Product change notification (PCN)

Title / short description	SACC with Screw Connection - Change to leadfree
Affected article category	Sensor/actuator cabling
Change category	Material, Form and appearance
Change number	CAF260072-00
Reason for PCN/PDN Revision

Product change notification – CAF260072 SACC M12 Screw Connection (M12 8pos. + M12 SH 4pos. 5pos)

Change to leadfree

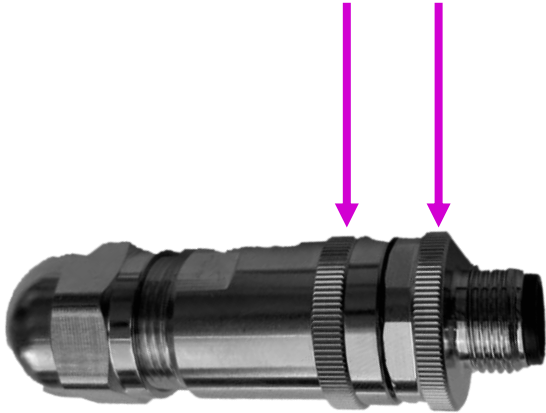
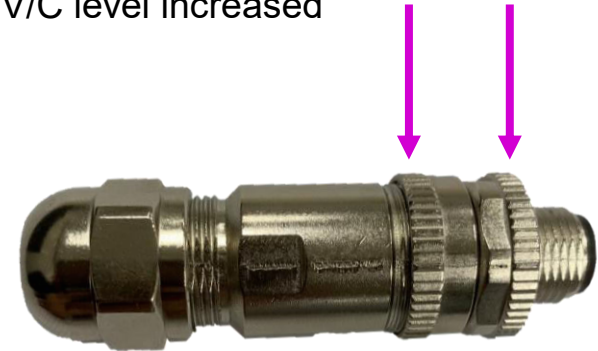
Small optical differences:

- The knurling was chosen a bit coarser for better manufacturability and better handling for assembly
- The color of the connectors (surface) is more dull and darker (no more brass coating; not so shiny)

Old:

Lead containing:

- Shiny coating
- Fine knurling

New:

Leadfree:

- ensures long-term compliance
- RoHS without exceptions
- Other visual color surface
- More coarser knurling (better manufacturability and handling for assembly)
- V/C level increased
